## CITY OF ST. PETERSBURG, FLORIDA

# Addendum to Staff Report

COA 17-90200047 – Proposed Dwelling at 736 18<sup>th</sup> Avenue Northeast

CERTIFICATE OF APPROPRIATENESS REQUEST

Figure 2: New construction proposed under COA 17-90200023, approved with conditions

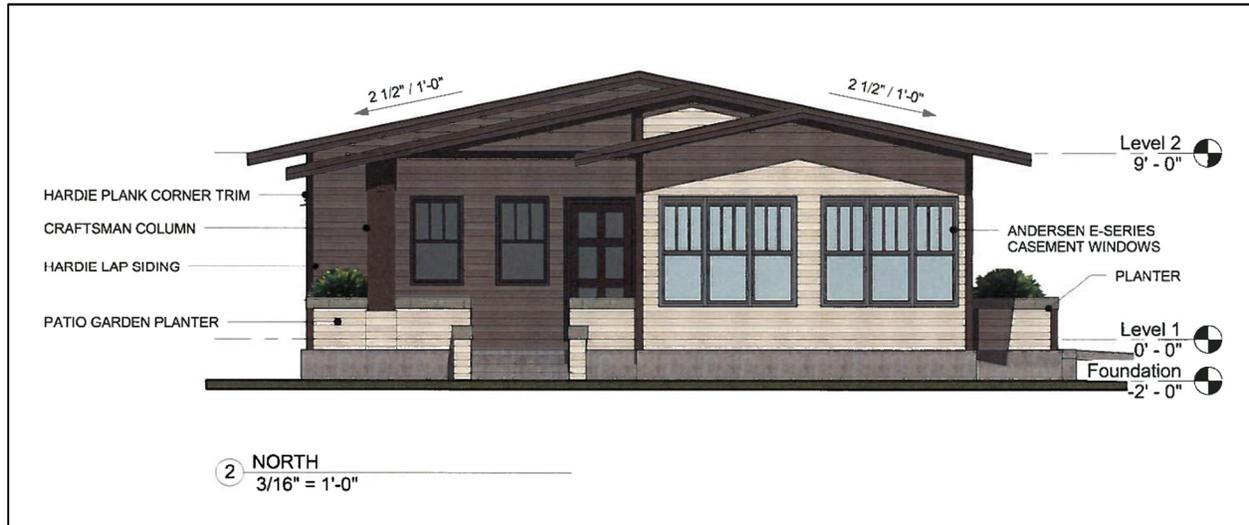
However, staff found the following elements of the proposed dwelling to be incompatible with the local district:

- Metal roof cladding is not sufficiently documented historically within the local district,
- Window patterns along the east (left), west (right), and south (rear) elevations are inappropriate,
- More information would be needed to determine the appropriateness of landscape preservation and wall composition,
- Some proposed fenestration patterns are too minimal, and
- The proposed carport design did not represent a building element historically found within the local district.

Staff recommended approval of COA 17-90200023, with the following conditions. After conversation between staff, the applicant, and Commissioners during the public hearing, the conditions that have been struck through were eliminated by motions initiated by Commissioners. The proposed new construction at 888 Roser Park Drive South was approved with the remaining nine conditions.

1. An additional carport support post shall be designed at the west elevation;
- ~~2. The roof cladding shall be changed to an appropriate composition material, or researched and documented metal material;~~

3. The building shall be sited to avoid the need for a setback variance;
4. The applicant shall submit a wall composition calculation sheet to staff as part of the COA approval. Additional, appropriate windows shall be added to the east, west, and south elevations, and require appropriate depth;

5. The proposed HardiePlank siding at the porch planter surrounds, steep cheek walls, and support posts shall be redesigned to better reference historic precedents;

- ~~6. A matching support post shall be added to the carport at the west elevation;~~
7. A landscape plan shall be submitted;
8. The applicant shall acknowledge archaeological potential at the subject parcel;

9. The west planter shall be evaluated for redesign or relocation;

10. An enhanced fenestration package shall be submitted to include added trim, sills, foundation skirting design, and other decorative detailing; and
11. The applicant shall preserve existing hex block and granite curbing.

Figure 3: New construction proposed under COA 15-90200053, approved with conditions

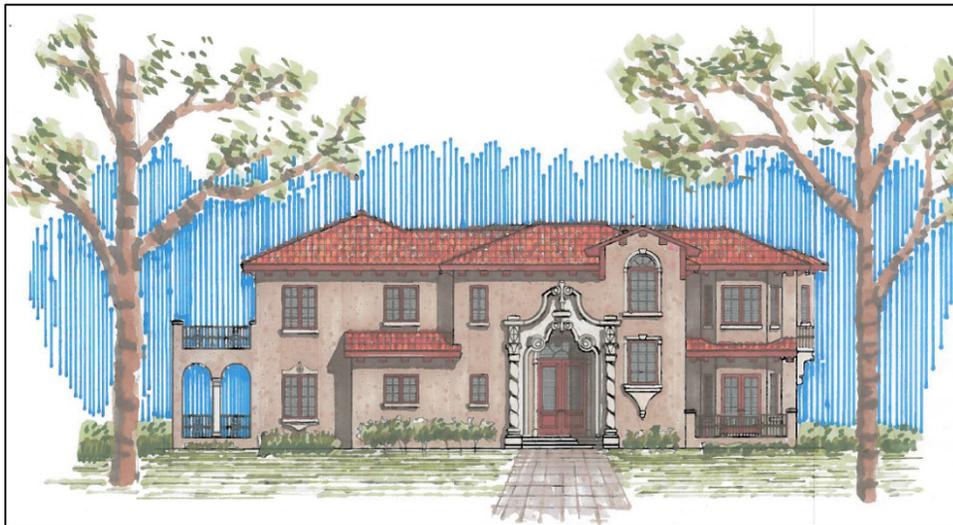
Staff recommended approval of COA 15-90200053 with the following required conditions:

- The applicant was to provide historical precedent from within the district of the hexagonal window bays seen at the right side of the façade, or alter this bump-out if none could be found; and
- The front walkway was to be narrowed to better reflect the relationship of entrances to the sidewalk within the district.

- Ornamental detail such as decorative tile be added between the two windows at the upper left of the façade to enhance the visual compatibility of the proposed dwelling's horizontality to contributing properties in the district;
- The proposed dwelling's visual texture be enhanced through the application of ornamental details to the upper level balconies at the north elevation; and
- The side entrance to the north elevation be better defined and articulated through the application of railings or other architectural treatment.

The Commission voted to approve COA 15-90200053 with all conditions suggested by staff.

Figure 5: Second Floor Plan of proposed dwelling, with added articulation along east elevation highlighted

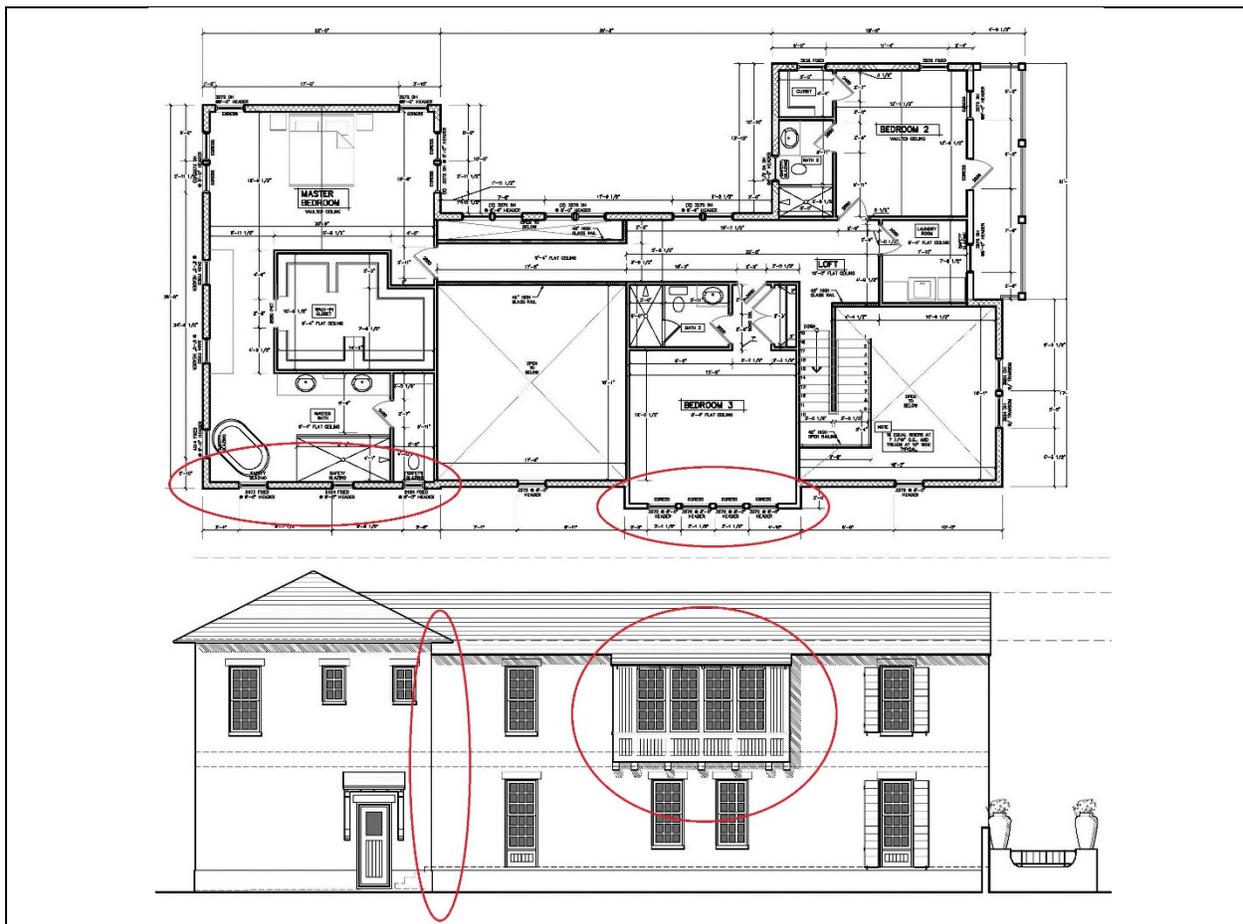
One concern expressed by neighboring property owners at the CPPC hearing of February 13, 2018 was of the visual impact of this continuous massing, most notably along the proposed dwelling’s east elevation. Staff included a recommendation to add articulation to this elevation in the original staff report, with the intention of creating a series of “visual breaks” in the appearance of the continuous wall that was, at that time, being proposed. These recommendations have been addressed by the applicant in the most recent revisions to the proposed dwelling (Figure 5).

Though minimal, the articulation at the north edge of the garage/master suite, encircled at left above, continues the visual break begun by the hipped roof element. The east elevation is further broken visually through the addition of an oriel, or bay window supported by brackets, encircled at right above.

Figure 6: Functionality of entrance to propose dwelling

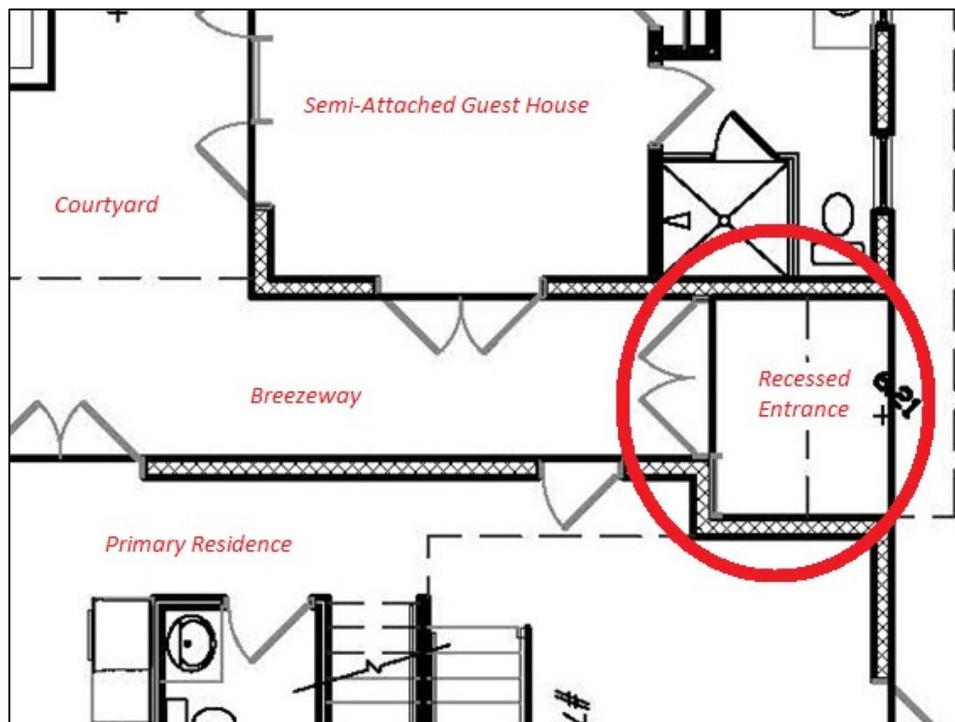
Plans for the proposed dwelling suggest an entrance that is recessed from the line of the façade approximately 4' 6", and opening into a partially-enclosed breezeway, from which the primary dwelling, functionally detached guest house, and interior courtyard are accessed (Figure 6). According to the *Historic and Archaeological Preservation Overlay*, review of new construction and alterations to designated buildings and structures (including those within designated historic districts), is limited to exterior changes. However, this interior functionality is noteworthy in that it relates to the placement of the recessed entry doors.

The proposed door itself features a tripartite windowed door, in which the two panels to the right are operable as a dual-action door (Figure 7). The left panel serves to conceal the narrowing depth of the interior corridor as compared to the recessed entrance as visible from the façade. As depicted below, this arrangement serves the purpose of aligning the entrance with upper-level window above it to maintain the three-bay rhythm of this portion of the façade.

The recessed entrance and breezeway are, for the purposes of calculating square footage and Floor Area Ratio (FAR), not counted as interior space. However, they are visually enclosed by the overall envelope and upper-level spaces of the proposed dwelling. This is noteworthy in the evaluation and discussion of volume to follow.

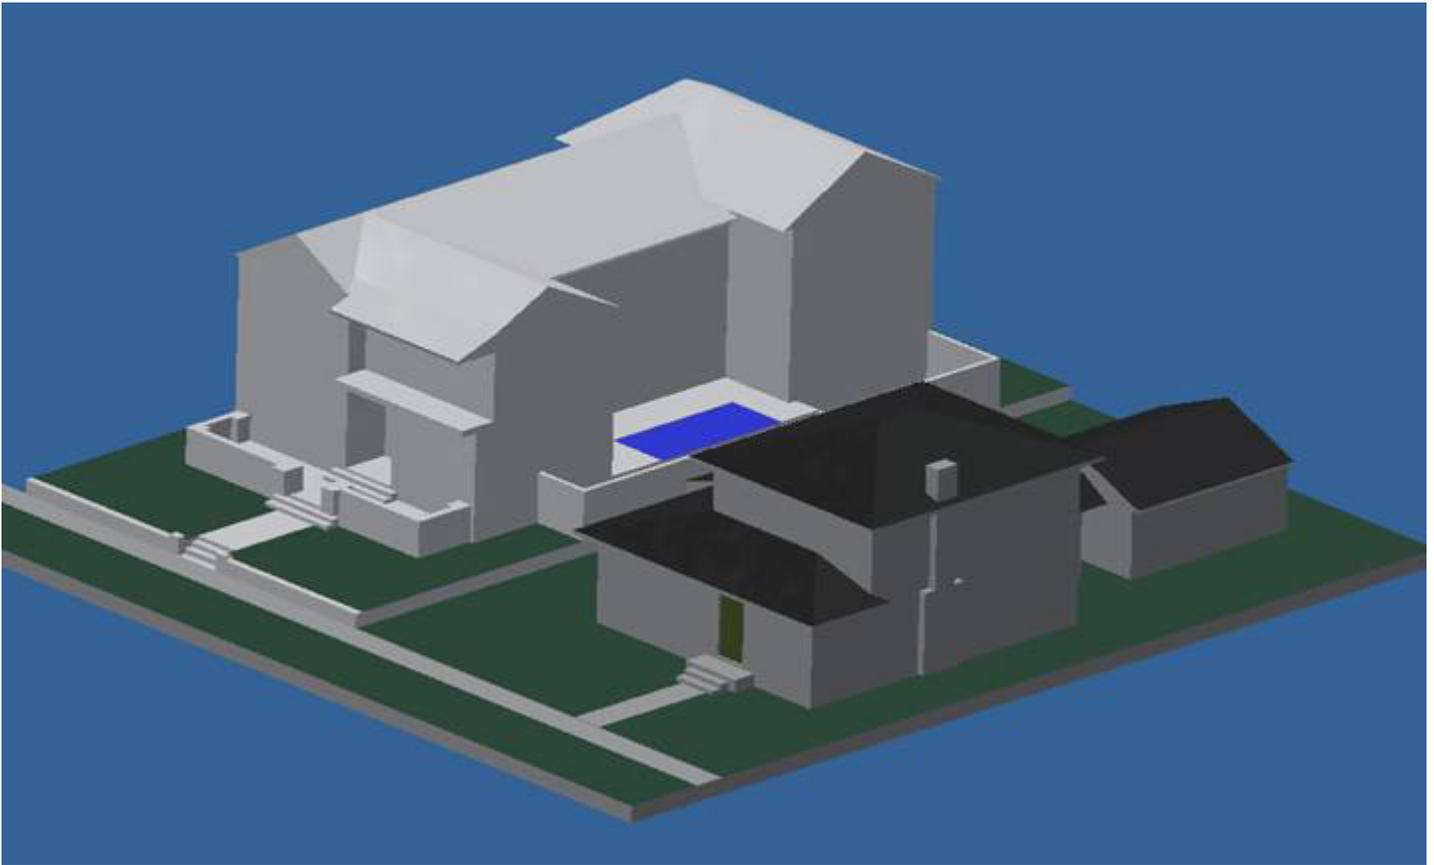
Thanks for the updates and information. I have obviously only had a short time to review the drawings, however I have begun to build full CAD models to allow the counsel to have a clear view of the massive size of the proposed new construction.

The models are built directly from McGinniss' drawing (some of which seem to have errors that present things in a very favorable light for him).

An initial screen shot can be seen here, showing the massive, inappropriate scale of the proposed house. I will be trying to add the 746 house and perhaps the present house for comparison, hopefully before we meet.
